Assessment report to Sydney Central City Planning Panel

Panel reference: 2016SYW084

DA number	JRPP-16-03307	Date of lodgement	4 April 2016
Applicant	Blue Diamond Projects Pty Ltd		
Owner	B Kurtz and D J Humphries		
Proposed development	2 residential flat buildings with basement parking and associated works		
Street address	138 Burdekin Road, Schofields		
Notification period	21 March to 20 April 2016	Number of submissions	None

Figure 1: Extract from the 4th Floor Plan demonstrating the treatment to the windows for the reduced building separation.

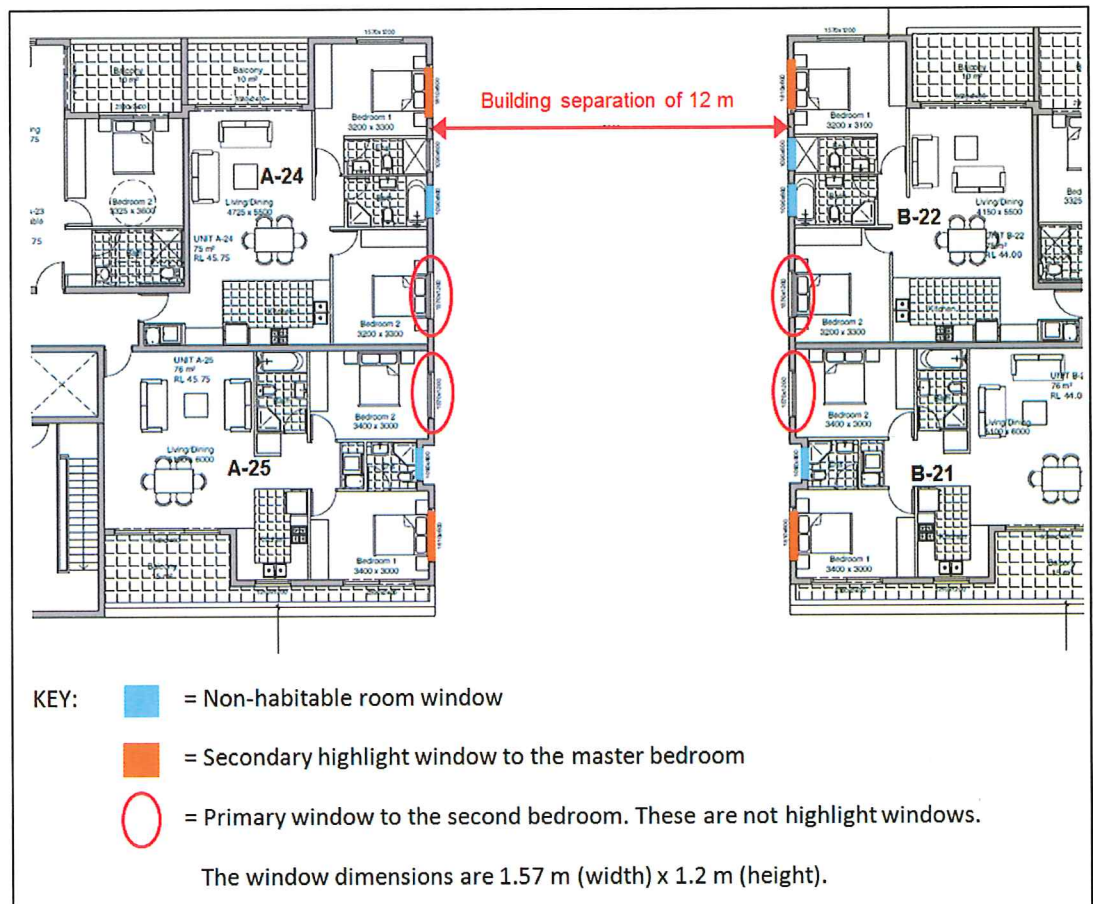
- 7.2.1 The proposal satisfies all building separation requirements in accordance with Section 2F Building Separation of the Apartment Design Guide (ADG), with the exception of the fifth level along the western component of the proposed RFBs. The proposal is required to provide a building separation distance of 18 m between

the habitable rooms of Apartments A24 and A25 to Apartments B21 and B22, however, only 12 m is provided.

7.2.4 Concern is raised that the 4 bedroom windows which are circled in red above are the only windows for these secondary bedrooms, and they are directly opposite each other. To ensure that direct lines of sight are avoided between these apartments, it is recommended that a condition of consent is imposed requiring the Bedroom 2 windows of Apartments B21 and B22 to be treated with visual privacy screens for the lower half of these windows. This is considered sufficient to ameliorate potential visual privacy concerns.
